Access Compliance Report

Public Rights-of-Way

(Curb Ramps)

Intersection ID: 47820	Main Street: HERONS_POND_CT	Cross Street: ROYAL_FERN_LN	Location: NW
ADA ID: 2DF083F71CBE	Ramp Type: Perp	Initial Pass/Fail: Fail	Overall Compliance: No
Severity Score: 21.25			
Codes/Mitigation Info/Possible Solution		Field Measurements/Component Compliance

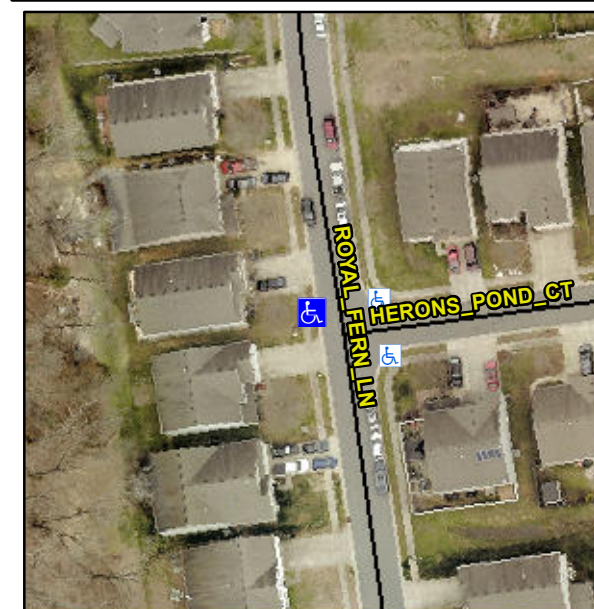
Not Found, R304.5.1, R304.5.3

Compliance	Description	Data	Compliance	Description	Data
N/A	Ramp Length (in)	49.0	Yes	Ramp Slope (%)	5.6
No	Ramp Width (in)	47.0	No	Ramp XSlope (%)	5.7
N/A	Flare Type LT	N/A	N/A	Flare Type RT	N/A
N/A	Flare Slope LT (%)	N/A	N/A	Flare Slope RT (%)	N/A
N/A	Flare Traversable LT?	N/A	N/A	Flare Traversable RT?	N/A
N/A	Landing Length (in)	N/A	N/A	DWS Provided?	N/A
N/A	Landing Width (in)	N/A	N/A	DWS Contrast?	N/A
N/A	Landing Slope (%)	N/A	N/A	DWS Length (in)	N/A
N/A	Landing X Slope (%)	N/A	N/A	DWS Full Width?	N/A
N/A	Landing Curb? (Y/N)	N/A	N/A	DWS Offset (in)	N/A
N/A	Shared Landing?	N/A			
N/A	Gutter Ponding?	N/A	N/A	Gutter Slope (%)	N/A
N/A	Gutter Lip Ht (in)	N/A	N/A	Gutter X Slope (%)	N/A
N/A	Painted X Walk1?	No	N/A	Painted X Walk2?	N/A
	X Walk 1 Direction	To E		X Walk 2 Direction	N/A
N/A	X Walk 1 Width (in)	N/A	N/A	X Walk 2 Width (in)	N/A
	X Walk 1 Slope (%)	2.6		X Walk 2 Slope (%)	N/A
	X Walk 1 X Slope (%)	6.4		X Walk 2 X Slope (%)	N/A

Remove & Replace Entire Ramp.
